IN THE DRAWINGS

REMARKS

Annotated Sheet Showing Changes

FIG. 4

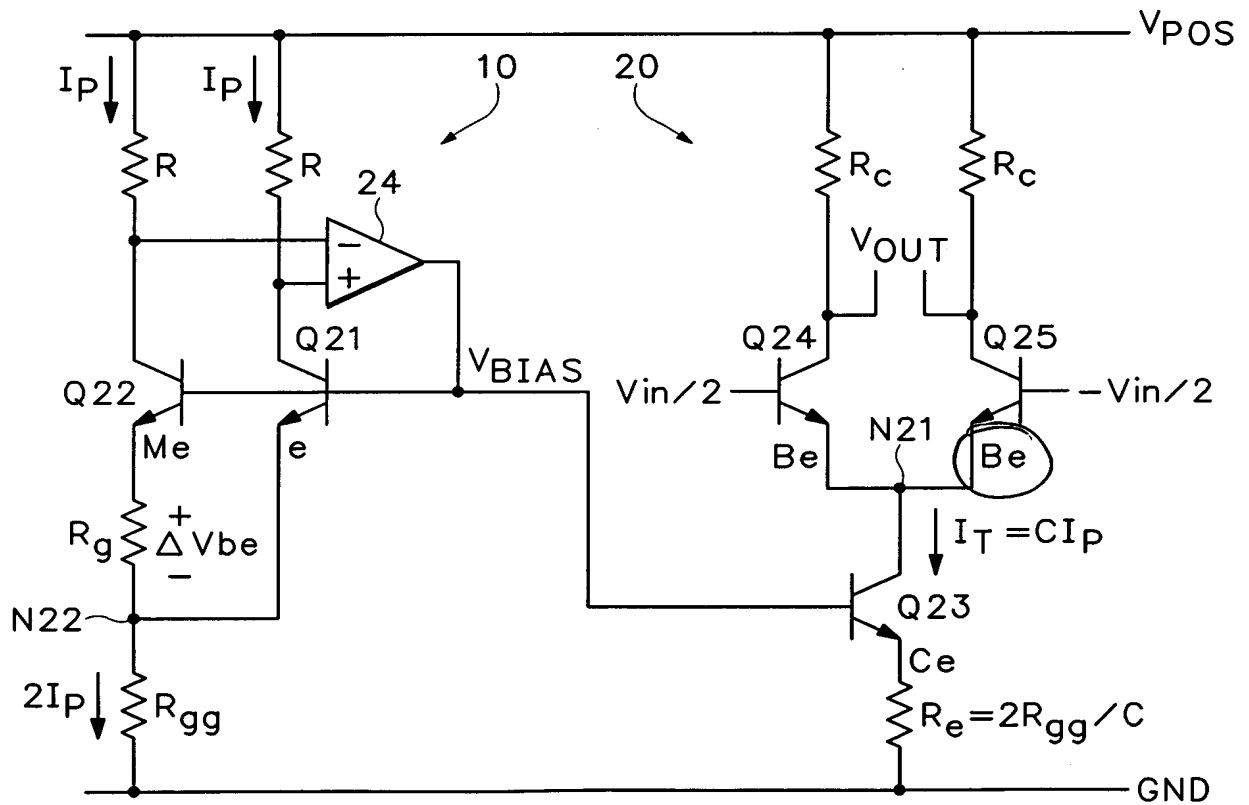
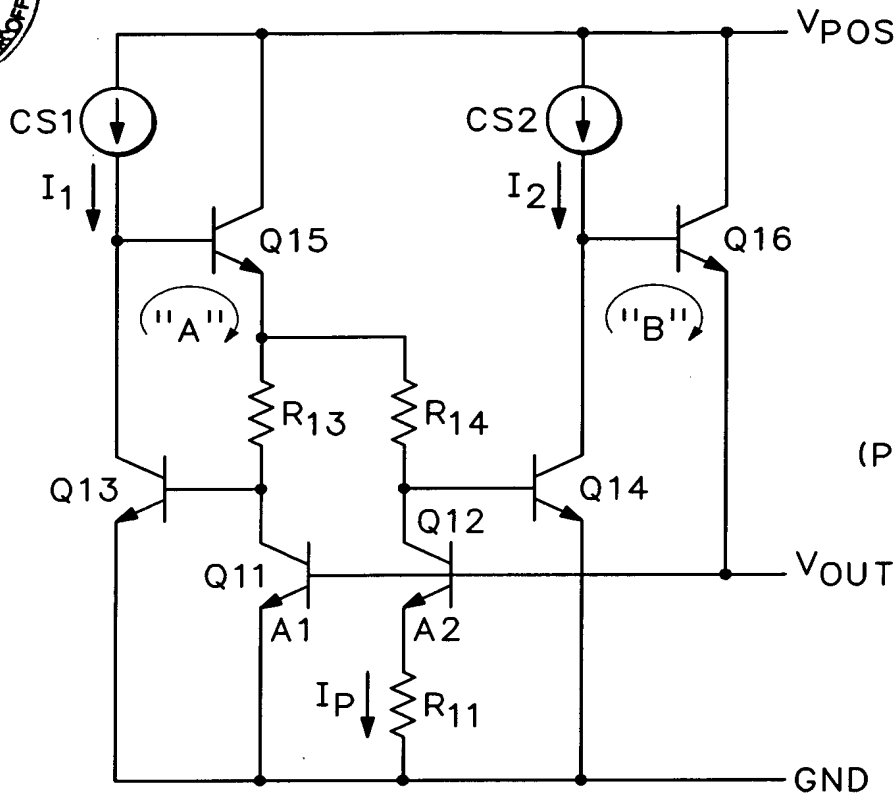
Fig. 4 is amended to correct an error and to conform to the specification. A Replacement Sheet including amended Fig. 4 is included as an attachment, as is an Annotated Sheet showing in detail the change made.

Fig. 4 is amended to conform to the specification.
